SUBMITTAL REVIEW

- ☐ NO EXCEPTIONS TAKEN
- ☐ MAKE CORRECTIONS NOTED RESUBMITTAL NOT REQUIRED
- ☑ AMEND AND RESUBMIT
- ☐ REJECTED - SEE REMARKS

ITEM 525.34 BRIDGE RAILING, GALVANIZED 4 RAIL BOX BEAM
ITEM 621.73 GUARDRAIL APPROACH SECTION, GALVANIZED 4 RAIL BOX BEAM
TH1 EAST RIVER ROAD BRIDGE #19
TOWN OF LINCOLN, VT ADDISON COUNTY
BRF 0188 (8)

TYPICAL RAILING ELEVATION

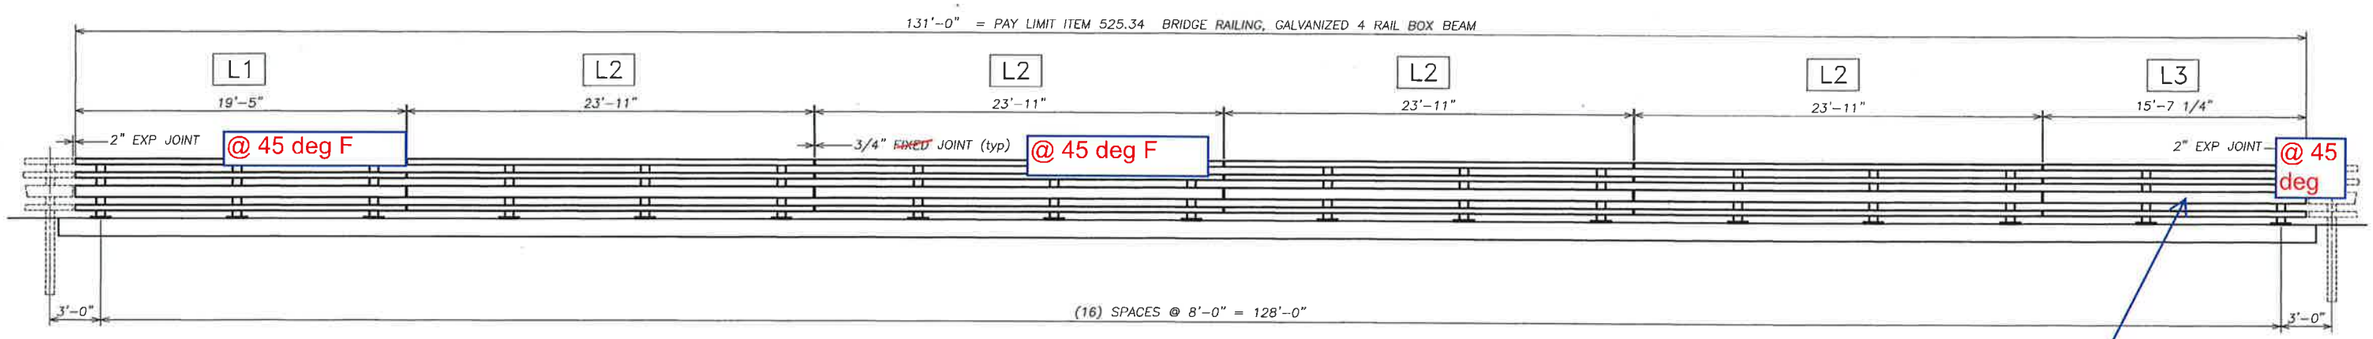
Per rail note 4 in the contract plans, rail tubing shall be attached to a min of 3 posts

FRONT POST ELEVATION

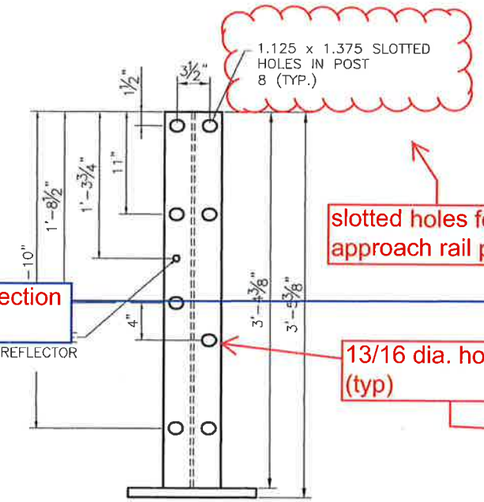
slotted holes for approach rail posts

Allowed per section B-B

13/16 dia. holes (typ)

Rail tubing shall meet the longitudinal charpy v-notch requirements of 15 ft. lbs at 0 deg F. test samples shall be taken after forming the tubes.

APPROACH RAIL @ W.W. 4

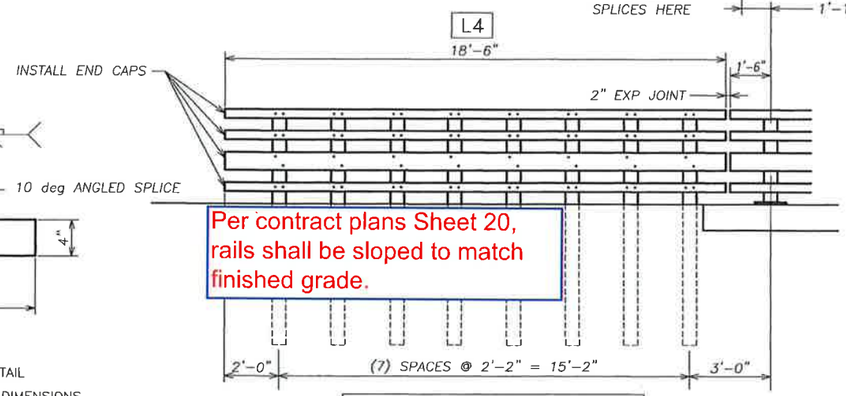
Per contract plans Sheet 20, rails shall be sloped to match finished grade.

STEEL POST CHART

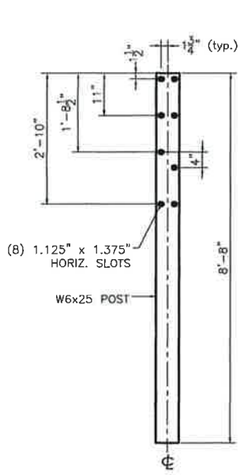
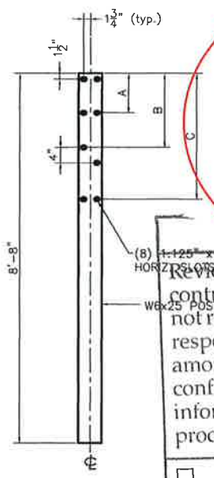
Please verify that this chart is still OK, after comments are addressed
